URANIUM CORPORATION OF INDIA LTD. JADUGUDA  
(A GOVT. OF INDIA, DEPARTMENT OF ATOMIC ENERGY ENTERPRISE)

REV. A

SUB. AGITATOR SHAFT SLEEVE  
FOR DISC FILTER (A,B & C)

DRG. NO. UC/M-781/A

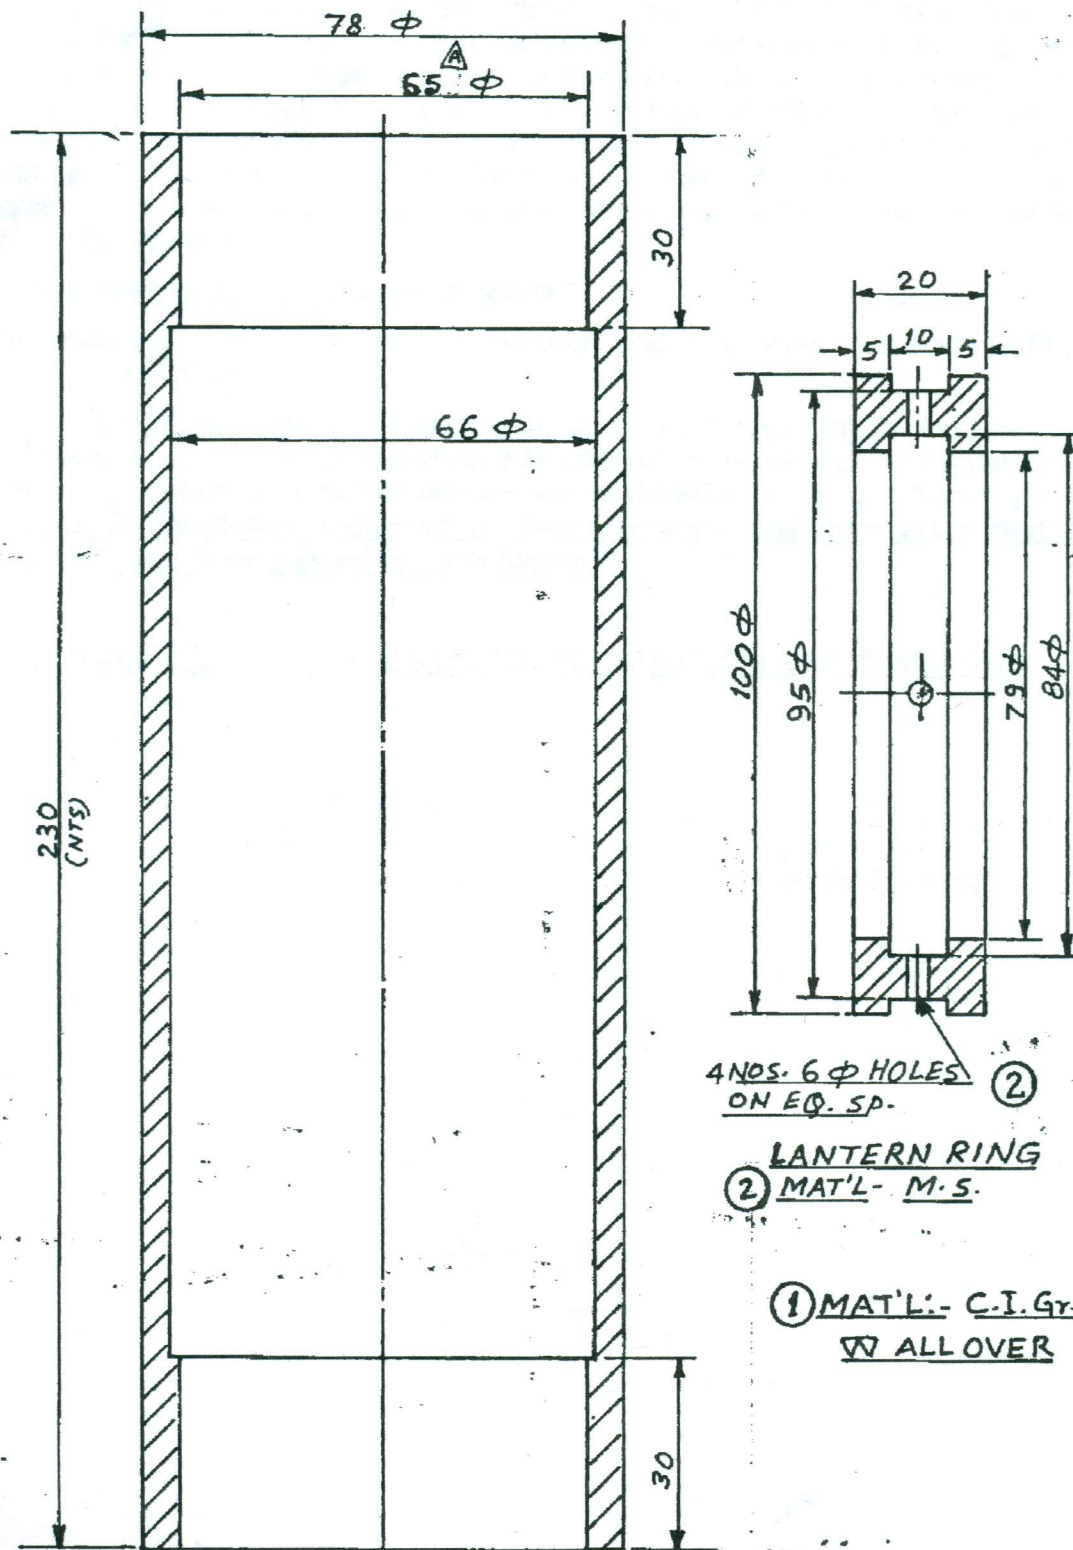
REV. A

I.D CHANGED FROM 63.8 mm  
TO 65 mm BY S. SUR ON

9.3.2000.
